Re: Drop Size Distribution Retrieval Using Dual-Polarization Radar Observations at C-Band and S-Band

Dear Editorial Team of AMT,

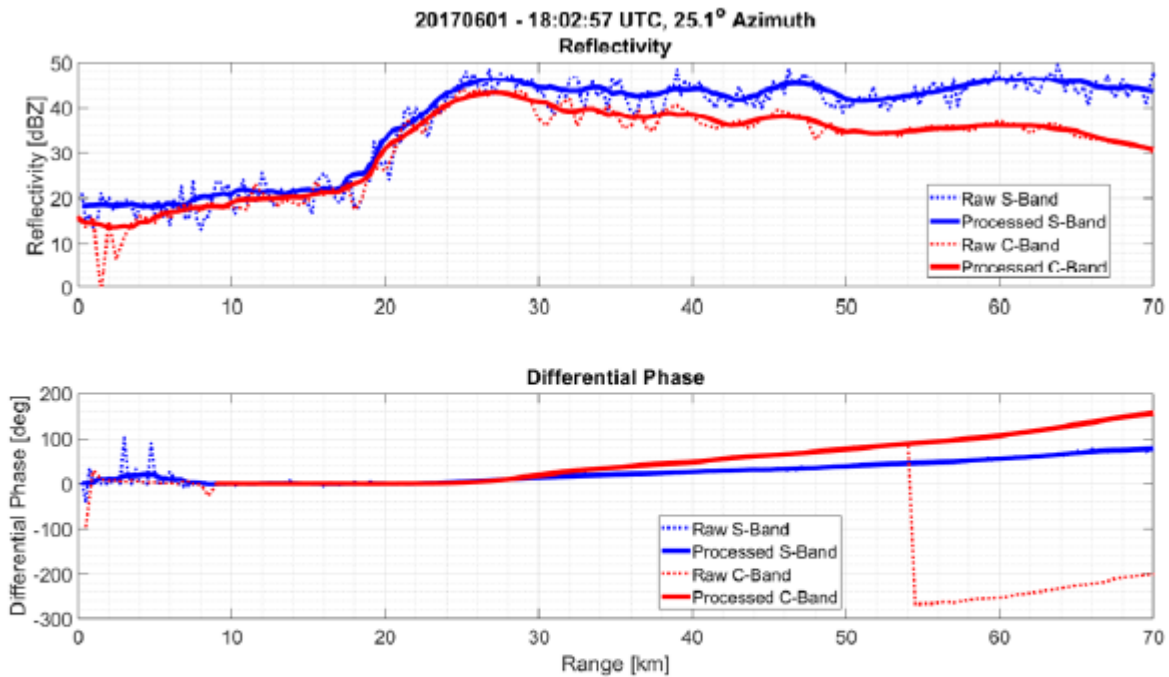
Section 2.2: Figure 4: Add the raw phidp to compare with the processed phip (FIR filtering). For easy comparison, the initial phase offset can be subtracted.

We have updated the figure to add the raw phidp. We have also added the raw reflectivity for completeness.

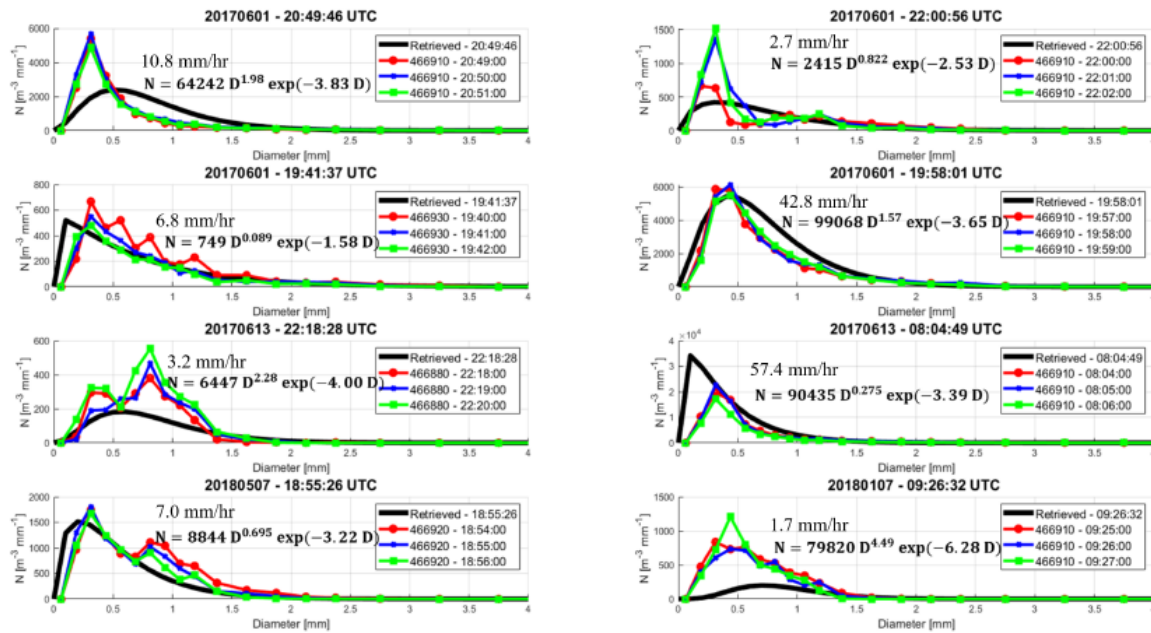
Section 3.1 Figure 8: Add the resulting rainfall rate values from disdrometers (blue line) to each subplot so that we can associate them with a rain intensities.

We have updated Figure 8 (now Figure 10) to include rainfall rates.

**Figure 12.** The retrieved calculated value of each parameter (y-axis) is shown relative to the algorithm’s input (x-axis) based on the radar measurements at the final gate (disdrometer location).

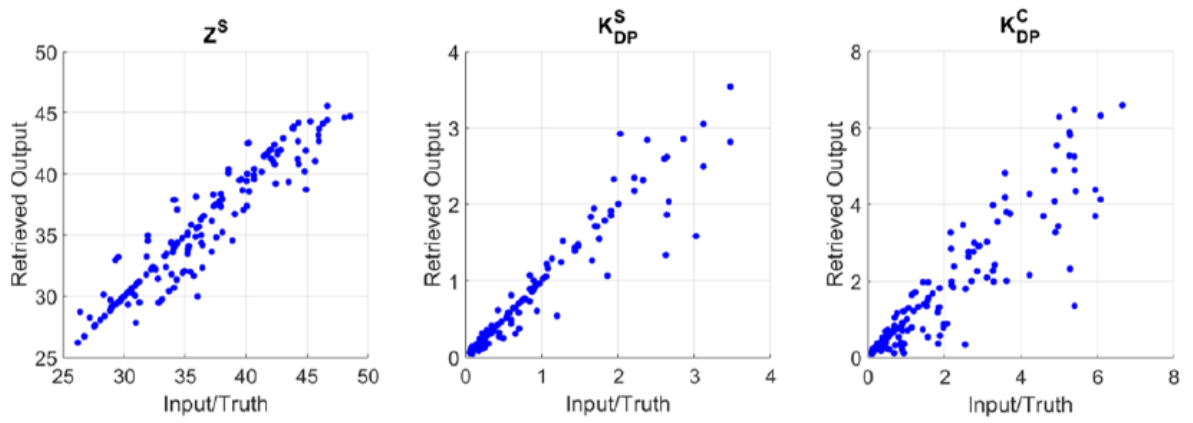
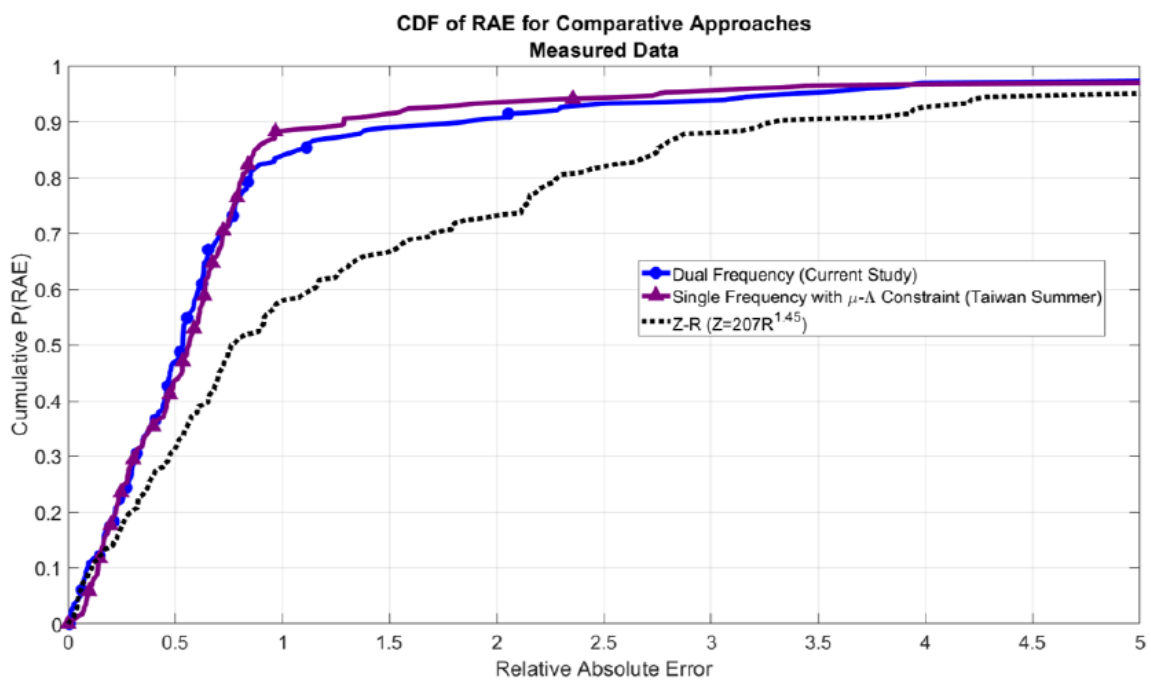
<b>Reviewer:</b> 2	<b>Comment Number:</b> R2-22
<b>Comment:</b> Section 3.2 This sections lack of statistical results. Showing a time series plot is not so relevant in this study. I would suggest using scatterplots and show metrics such as RMSE, Bias, correlation, etc. For instance, a scattering plot related to the attenuation correction: Z(retrieved DSD) vs Z(disdrometer). And two more related to KDP and Rainfall rate.	
<b>Reply:</b> We appreciate the reviewer’s suggestions. To address the reviewer’s comment, we have updated the manuscript to include scatter plots of retrieved vs. input values for $Z$ , $K_{DP}^S$ , and $K_{DP}^C$ . We have also included the calculated correlation coefficients in the manuscript text. We recognize that the statistical results of rainfall are normally evaluated either in the accumulated (e.g., hourly based or days based) format (e.g. Wang et al. 2013, Zhang et al. 2016, Zhang et al. 2020), or in a relatively large scale of rain rate (Scarchilli et al. 1993). However, based on our current available data, such statistical analysis is not feasible. Currently, we are collecting more data for such a goal, and will present additional statistical results in future work. The time-series data (relative absolute error) has been reformatted in terms of a cumulative error distribution which is much more interpretable. <p>In the revised manuscript, new figures and discussions are included.</p> <p>Wang, Y. J. Zhang, A. Ryzhkov, L. Tang, 2013: C-band polarimetric radar QPE based on specific differential propagation phase for extreme typhoon rainfall. JTECH. <a href="https://doi.org/10.1175/JTECH-D-12-00083.1">https://doi.org/10.1175/JTECH-D-12-00083.1</a></p> <p>Jian Zhang, et al., 2016: Multi-Radar Multi-Sensor (MRMS) Quantitative Precipitation Estimation: Initial Operating Capabilitie. BAMS</p> <p>Gianfranco Scarchilli, et al. 1993: Rainfall estimation using polarimetric techniques at C-band frequencies. JAMC.<a href="https://doi.org/10.1175/1520-0450(1990)029&lt;0561:MRTSUC&gt;2.0.CO;2">https://doi.org/10.1175/1520-0450(1990)029&lt;0561:MRTSUC&gt;2.0.CO;2</a></p> <p>Jian Zhang, et al. 2020: A dual-polarization radar synthetic QPE for operations. JHM.<a href="https://doi.org/10.1175/JHM-D-19-0194.1">https://doi.org/10.1175/JHM-D-19-0194.1</a></p>

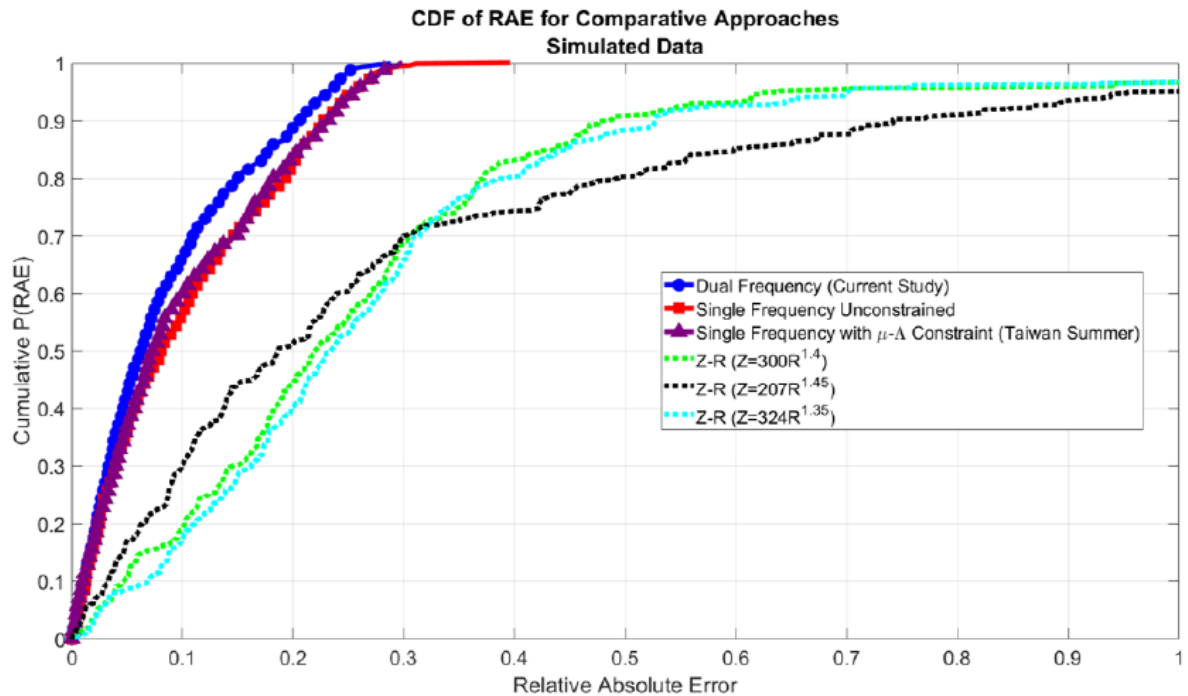
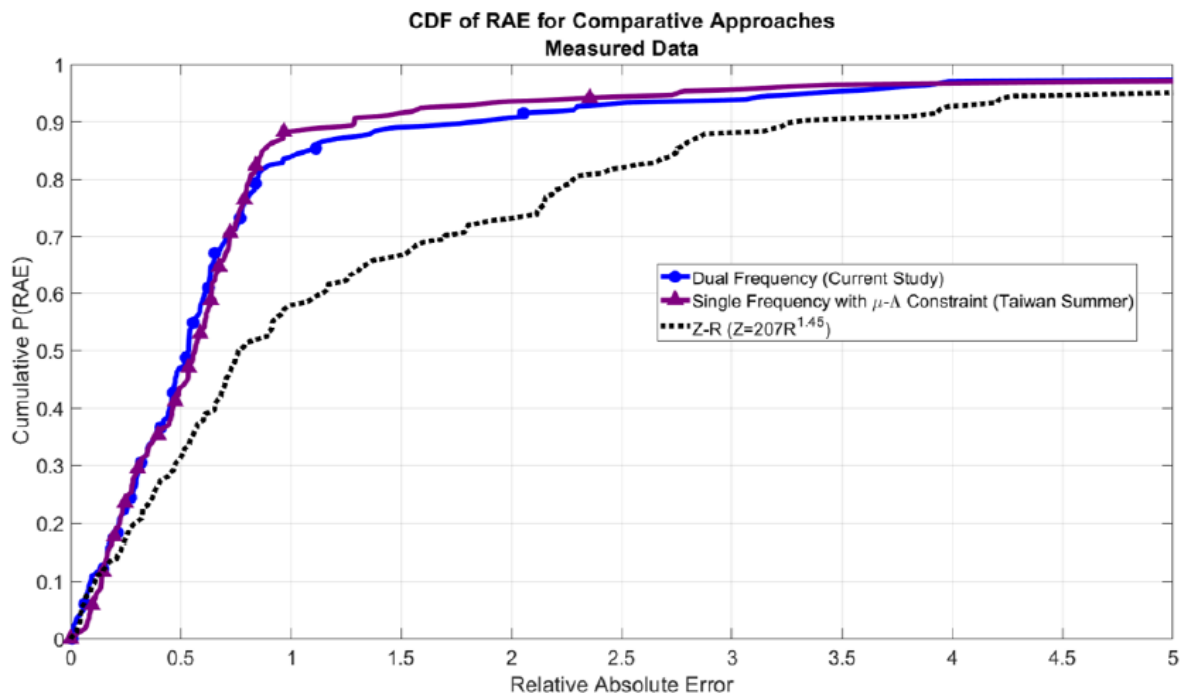
<b>Reviewer:</b> 3	<b>Comment Number:</b> R3-1
<b>Comment:</b> 1. The authors addressed my question #5 in their Response (See their Reply to RC1, Comment Number 6), which suggested that the proposed method be compared with single-wavelength radar observations and a mu-lambda constraint. The Response states that the proposed method and the mu-lambda constraint method produce similar results. Thus, the proposed method is not better than a single frequency method using a mu-lambda constraint. However, this comparison is not included in the manuscript. The manuscript should include the single frequency mu-lambda constraint method as a benchmark to show that the proposed method produces similar results.	
<b>Reply:</b> A comparison with the mu-Lambda constraint is now included with both simulated data and the measured/truthed data. The errors of each are much more clearly demonstrated in the form of a cumulative distribution rather than a time series plot.  Update for simulated data: “Figure 8 illustrates the cumulative distribution of errors for each method. In this plot, the cumulative portion of errors is shown on the y-axis, while the sorted error values of each method are displayed on the x-axis. As an example interpretation of the plot, 90% of current study’s errors (blue) are less than 0.2 in terms of RAE, while 90% of the Tawain Z- R based errors(black dashed) are not contained until an error level of 0.78 RAE. Interpreting the plot from the constant RAE perspective, 65% of the current study’s errors are below 0.1, while 60% of $\mu - \Lambda$ (purple) method’s errors and 30% of the Tawain Z- R (black) method’s errors are below 0.1 RAE. The conclusion of the simulations can be drawn from the plots: the dual frequency approach provides a modest improvement over single frequency retrievals, even with a relevant $\mu - \Lambda$ constraint, and a significant improvement compared to all Z-R based rates. Under these ideal simulated conditions, the median RAE of the dual-frequency approach was 0.0623 while the $\mu - \Lambda$ single-frequency approach was 0.0725. The median RAE of the best performing (at the 50th percentile) Z-R relationship ( $Z = 207R^{1.45}$ ), was 0.1861.”

“Figure 13 features a plot of the cumulative distribution of RAE for all three methods. The retrieval algorithm’s accuracy is depicted by the blue-circles line, while the  $\mu - \Lambda$  constrained retrieval is shown in purple, and the Z-R relationship benchmark is indicated with the dashed black line. This visualization highlights that the proposed method of estimating rainfall rates using retrieved DSD parameters significantly enhances accuracy over a region-specific Z-R relationship (Chang et al., 2021). Specifically, the median RAE for the Z-R method is 0.76, while the retrieval results correspond to a median of 0.53, marking a notable improvement of 30.3 % in this study’s context. The dual-frequency approach is comparable to the single-frequency constrained approach and the only claimed relative benefits are not needing to ascertain a regional  $\mu - \Lambda$  relationship or cases in which the precipitation deviates from the assumed relationship.”

**Figure 9.**  $K_{DP}$  is simulated for DSDs of varying  $\mu$  and  $\Lambda$  values with fixed  $N_0 = 8000$ . A separation between the  $K_{DP}$  values is clear at the two radar bands.

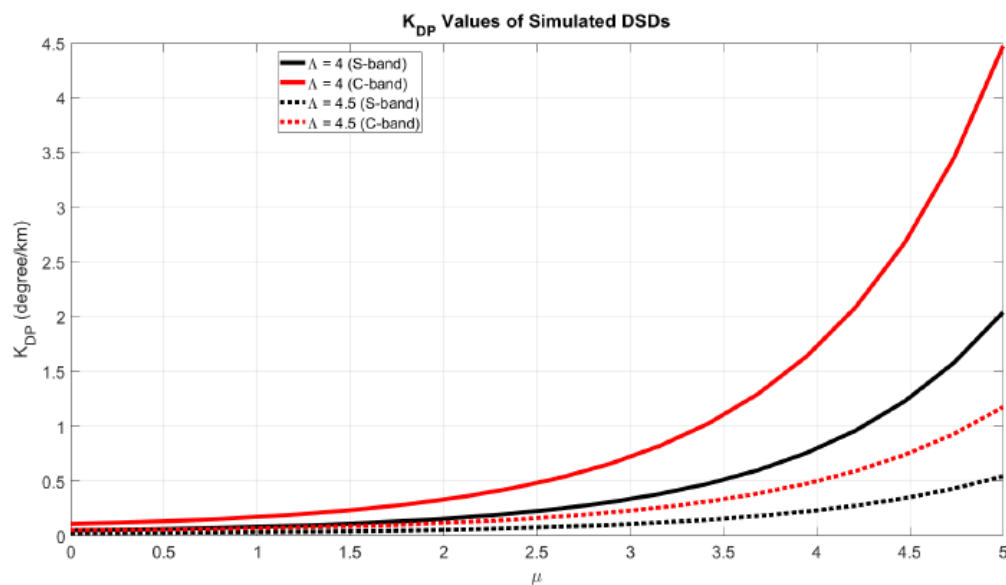
3. The simulations shown in Figure 9 are misleading because they are incomplete and do not represent the observed rain systems. For example, the simulation values of  $N_0 = 8000$ ,  $\mu = 2$ , and  $\lambda = 2$  will produce reflectivity factors over 55 dBZ (I am using formulas given in Ulbrich 1983 J. Clim. Appl. Meteor.). The manuscript should either remove the simulations (and Figure 9) or add a more thorough simulation analysis that includes rain systems observed by the radars and the possible correlation between DSD parameters.

We have updated the manuscript to include a dedicated simulation section which involves performing retrievals on simulated data in order to examine the performance in an ideal setting.

We believe the simulation at the parameter level is still valuable and have thus updated it to include values that are more representative of our data set. The reflectivity factor for the DSDs generated by the combined gamma parameters of the plot should not exceed 45 dBZ.
